[Docket No. FAA-2012-0060; Directorate Identifier 2012-NE-02-AD; Amendment 39-17123; AD 2012-14-09]

Airworthiness Directives; Pratt & Whitney (P&W) Division Turbofan Engines

ACTION: Final rule.

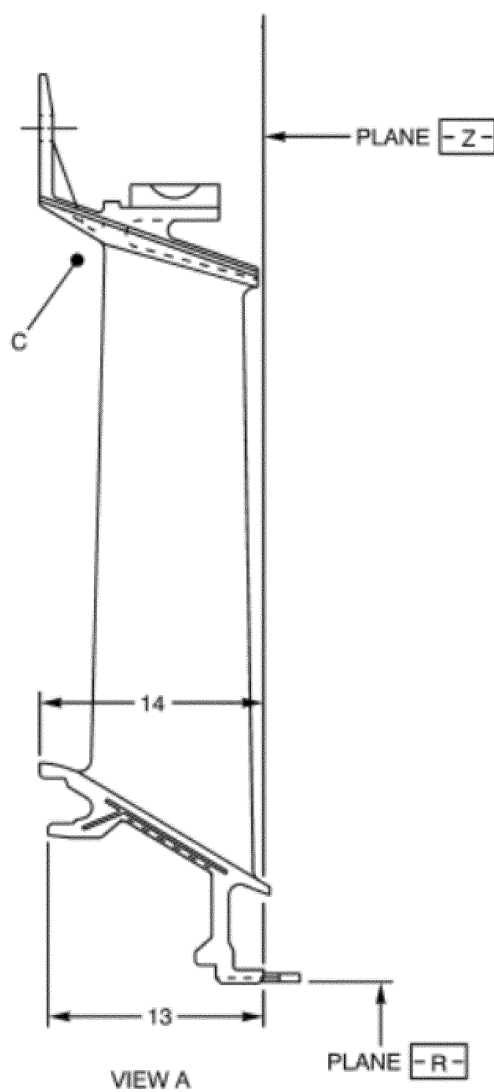
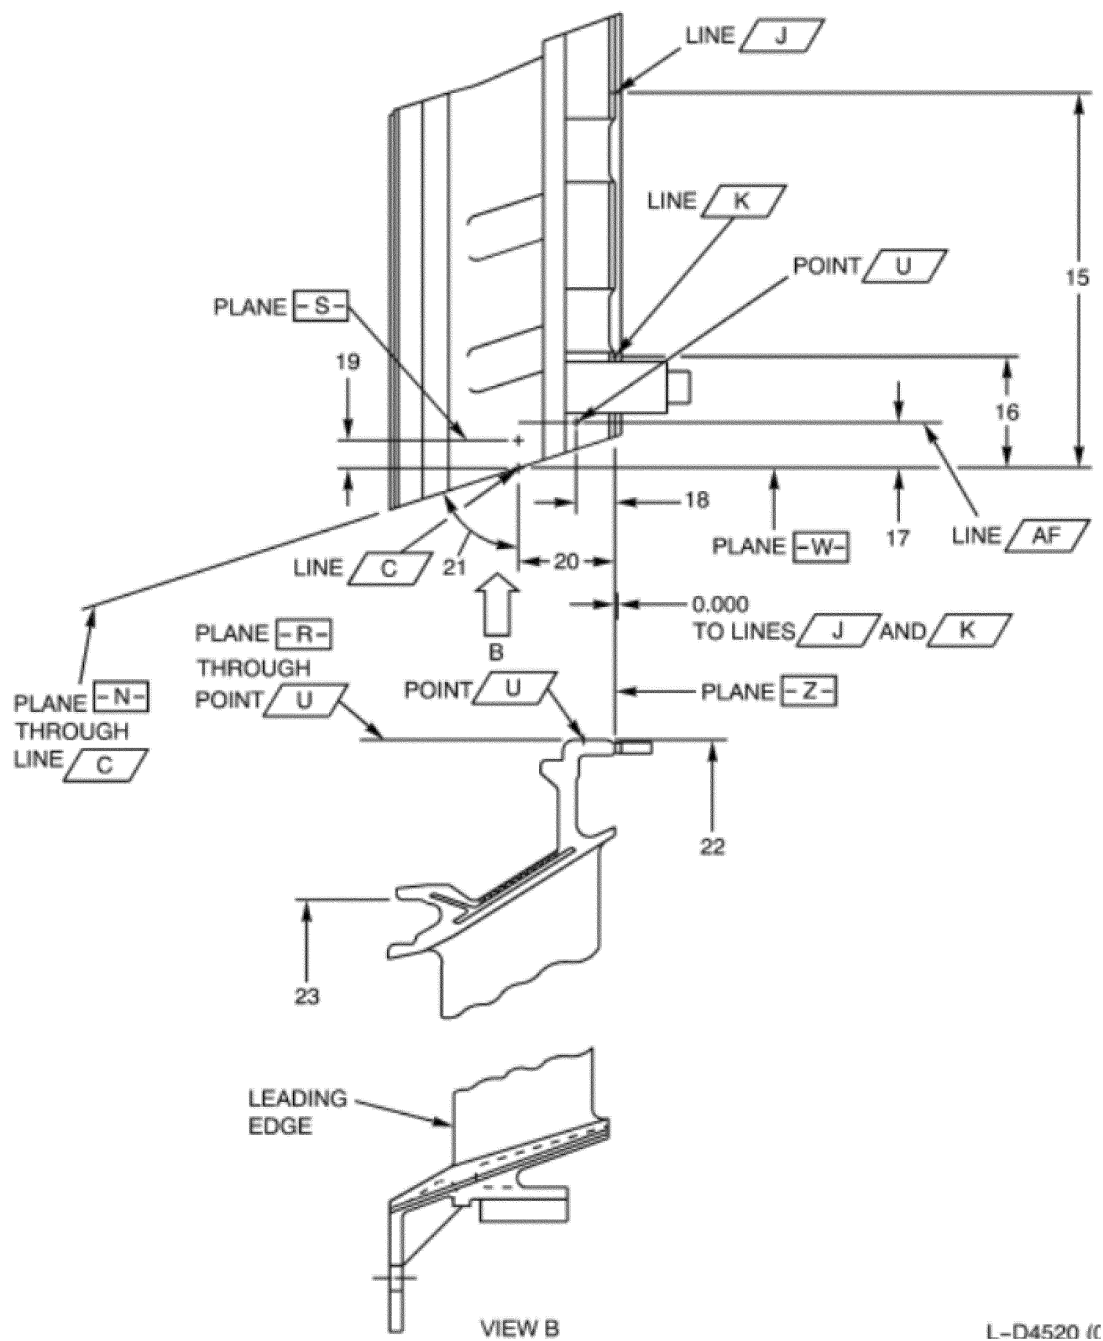
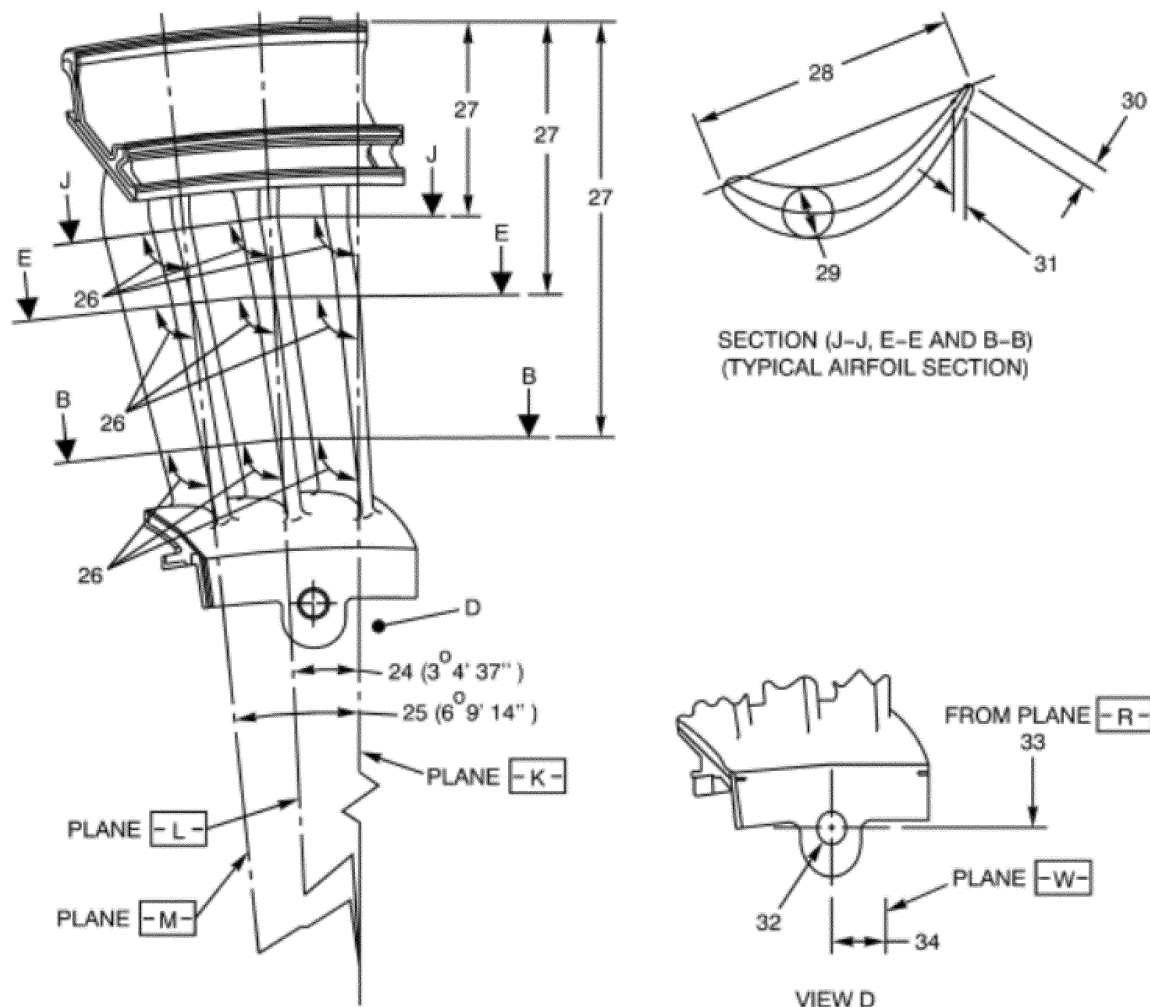
United Airlines requested that in proposed AD paragraphs (e)(1)(iii) and (e)(1)(iv), we change "ensure adequate engagement" to "dimensionally inspect the applicable LPT case slot serviceable dimensions and 3rd stage vane serviceable dimensions per the appropriate CIR." The commenter also requested that we list the specific dimensions to inspect by index number. The commenter stated that no mechanic can deduce what an adequate engagement is because it is not specific enough.

We agree. We changed paragraph (e)(1)(iii) to "dimensionally examine index 13 through index 34 of the LPT 3rd stage vane cluster assembly." We also changed paragraph (e)(1)(iv) to "dimensionally examine index 23 and index 24 of the vane engagement slots on the rear turbine case, where the 3rd stage vane is installed." We also listed the specific dimensions to inspect by index number, and included the supporting figures in this AD.

(iii) Dimensionally examine index 13 through index 34 of the LPT 3rd stage vane cluster assembly. Use Table 2 to paragraph (e) of this AD and Figure 1, Figure 2, and

Figure 3 to paragraph (e) of this AD to determine whether the vane is eligible for installation.
